Device TC1766
Marking/Step ES-BD, BD
Package PG-LQFP-176-2

02967AERRA

This Errata Sheet describes the deviations from the current user documentation.

Figure 1

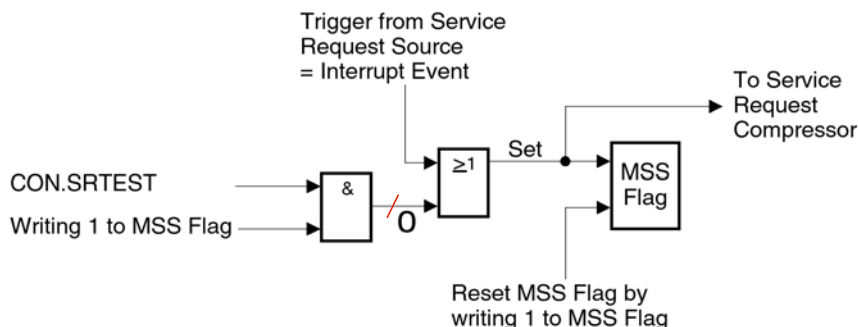
It is possible to generate a software triggered interrupt event in TESTMODE (ADCx_CON.SRTEST=1) by setting one of the bitflags in register ADCx_MSS0/1. Due to the fact, that this mechanism is not working, it is not possible to generate a corresponding interrupt by software.

Figure 2 Timing concerning equidistant multiple timers

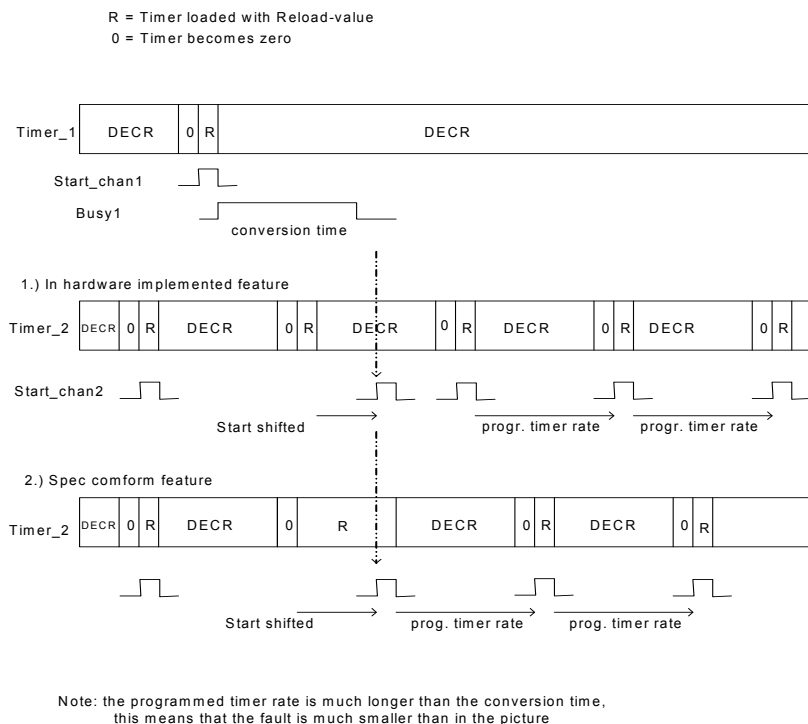
The correct behavior would be a reload when the requested conversion (of channel_2) is started.

Therefore the start of conversion for channel_2 is delayed by maximum one conversion-time. After this delay it will be continued with equidistant conversion-starts. Please refer to the following figure.

Figure 3 **Uncritical transmission**

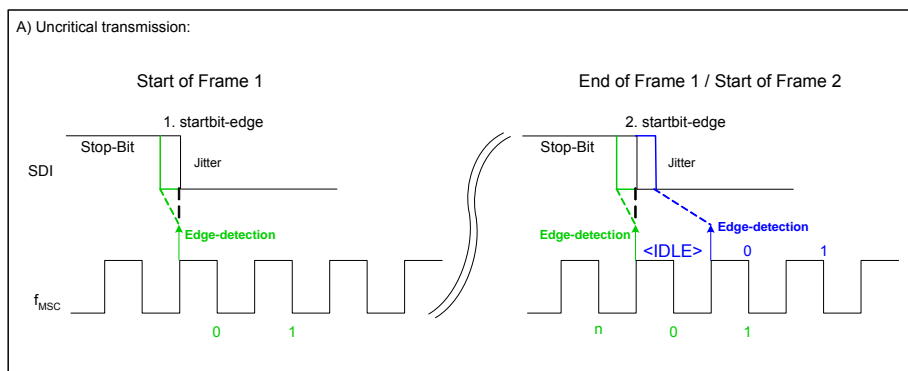
Therefore the state machine of the upstream channel is sensing for an incoming new startbit (high-low edge) in the last state of a frame. If there is no edge, the state machine changes to idle state. If an edge is recognized, the state machine will start receiving the next frame. Under certain timing conditions, the start-bit of an upstream-frame which is send without any idle-time, directly after the previous frame, will not be recognized and therefore this frame will not be received correctly. In that case the startbit might be recognized erroneously within the dataframe. The missbehaviour can occur if the high-low edge of the start-bit is located close to the rising edge of the internal MSC module-clock and is jittering around this clock-edge.

As the falling startbit edge is shifted to the left of the rising clock edge (**Figure 3** left), there occurs a secure detection of the next start-bit edge in the last cycle of the previous frame (here cycle n, **Figure 3** right) independent from the applied jitter to this edge.

Figure 4 Critical transmission

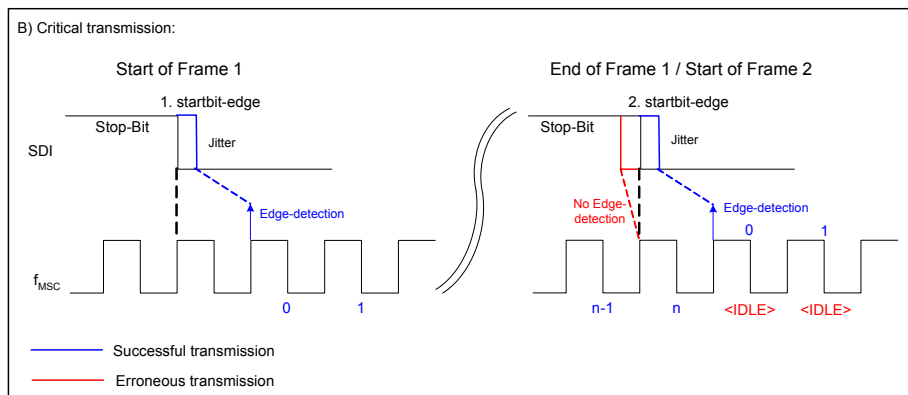
If the high-low edge of the start-bit in the first frame is just not detected by the near clock-edge (**Figure 4** - left) and the start-bit edge of the second frame is jittering to cycle $n-1$ (**Figure 4** - right, red coloured), then an erroneous transmission will take place. In this case the state-machine switches to IDLE after the last state n and wakes up on the next falling edge that may be a data-bit recognized as a start-bit. If the start-bit of the second frame is jittering to cycle n (**Figure 4** - right, blue colored), then the state-machine will not switch to IDLE but will start receiving the next frame correctly.

Figure 5 Delay adjustment relative to the module clock

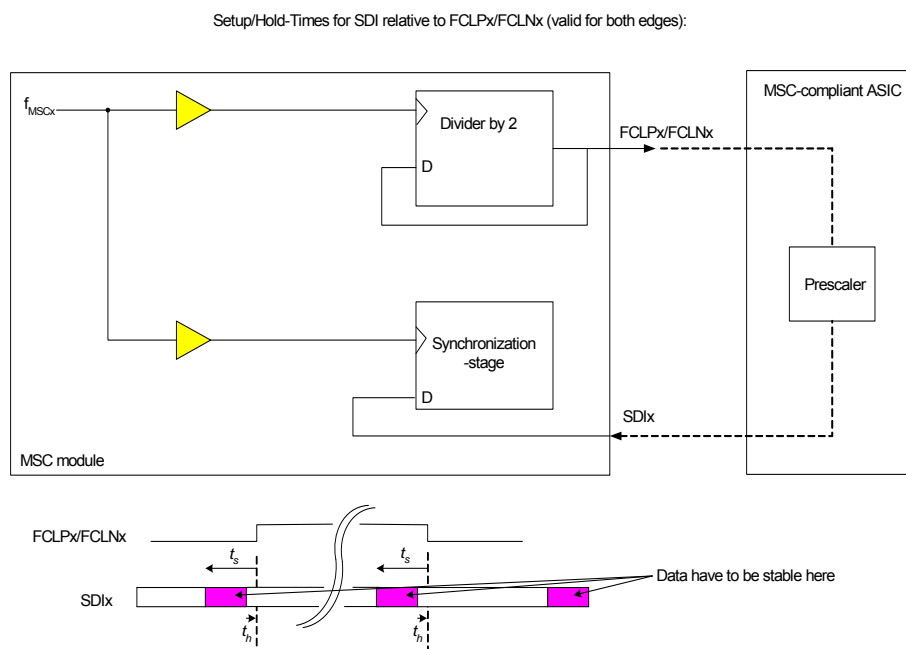
The delay depends on the maximal skew in the data-stream. For this workaround the downstream clock FCLPx/FCLNx can be measured as reference and the data stream at the input of the upstream channel SDIx has to be adjusted according to the setup- and hold-times of the input-pins SDIx.

Figure 5 shows the principle blockdiagram of the input synchronization stage of the MSC module.

The values for setup- and hold-times are listed in the following table. They were taken out of the timing analysis tool of the microcontroller device and apply to both, the rising and the falling edge.

Figure 9 Current accuracy range

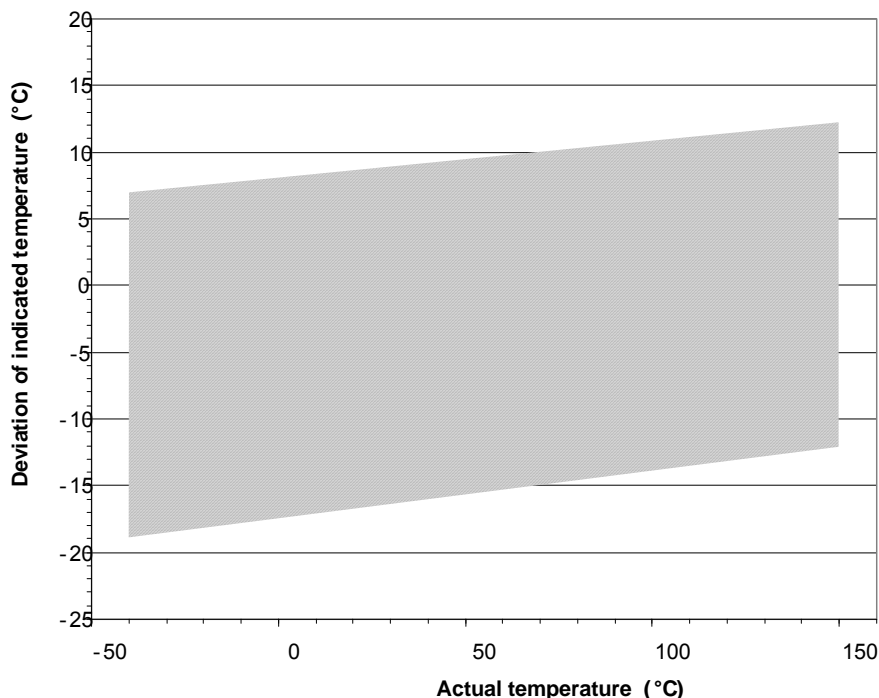
The accuracy of the DTS deviates from the values specified in the Data Sheet.
The formulas available on the specification are as follows:

- $\pm 12^{\circ}\text{C}$ at $T_J = 150^{\circ}\text{C}$
- $\pm 9/-17^{\circ}\text{C}$ at $T_J = 25^{\circ}\text{C}$
- $\pm 7/-19^{\circ}\text{C}$ at $T_J = -40^{\circ}\text{C}$

Figure 10 Exemplary power-up/down sequence

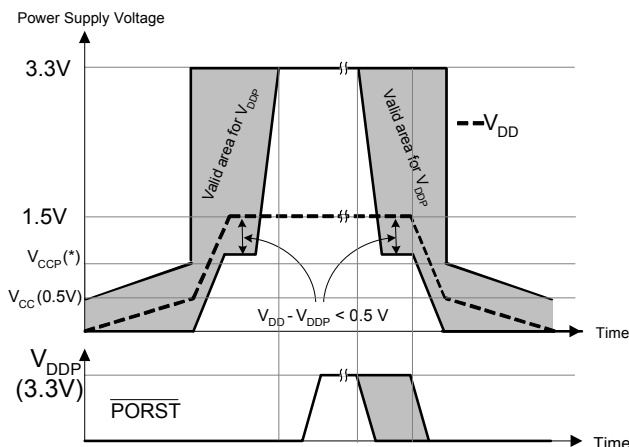
As per Data Sheet, $V_{DD} - V_{DDP} < 0.5\text{ V}$ has to be valid at any time in order to avoid increased latch-up risk. The figure below shows the possible V_{DDP} values as shaded region for an exemplary V_{DD} ramp. Moreover, the following rules apply:

- All analog voltages (V_{DDOSC3} , V_{DDM} , V_{DDMF} , V_{DDFL3}) must also follow V_{DDP} power-up/down sequence.
- V_{DDAF} , V_{DDOSC} must follow V_{DD} power-up/down sequence.
- The absolute value of the maximum allowed deviation between any two supplies is 0.5 V while the 1.5V supplies are below their specified operating conditions.

Note: V_{CC} and V_{CCP} in [Figure 10](#) refer to devices with PWR_TC.P009 erratum.

Figure 11 Alert Interrupt Behavior in case of Bus-Off

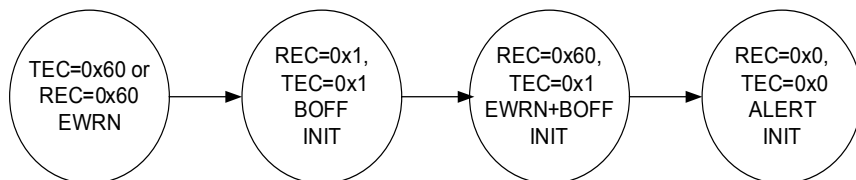
The MultiCAN module shows the following behavior in case of a bus-off status:

When the threshold for error warning (EWRN) is reached (default value of Error Warning Level EWRN = 0x60), then the EWRN interrupt is issued. The bus-off (BOFF) status is reached if $TEC > 255$ according to CAN specification, changing the MultiCAN module with REC and TEC to the same value 0x1, setting the INIT bit to 1_B, and issuing the BOFF interrupt. The bus-off recovery phase starts automatically. Every time an idle time is seen, REC is incremented. If REC = 0x60, a combined status EWRN+BOFF is reached. The corresponding interrupt can also be seen as a pre-warning interrupt, that the bus-off recovery phase will be finished soon. When the bus-off recovery phase has finished (128 times idle time have been seen on the bus), EWRN and BOFF are cleared, the ALERT interrupt bit is set and the INIT bit is still set.

Figure 12 Loss of Arbitration

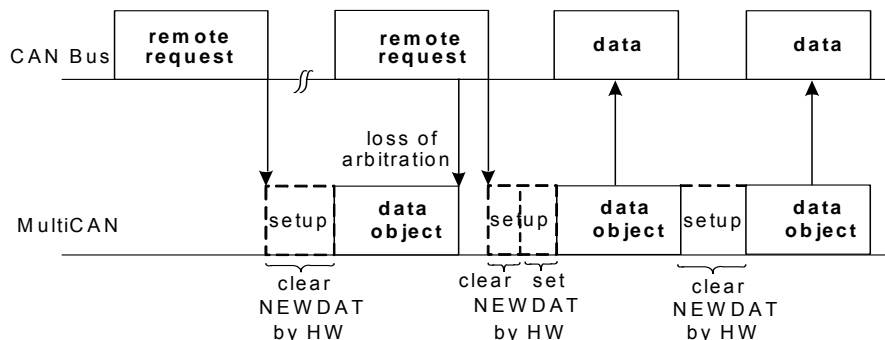
When the appropriate message object (data frame) triggered by the first remote frame wins the arbitration, it will be sent out and `NEWDAT` is not reset. This leads to an additional data frame, that will be sent by this message object (clearing `NEWDAT`).

There will, however, not be more data frames than there are corresponding remote requests.
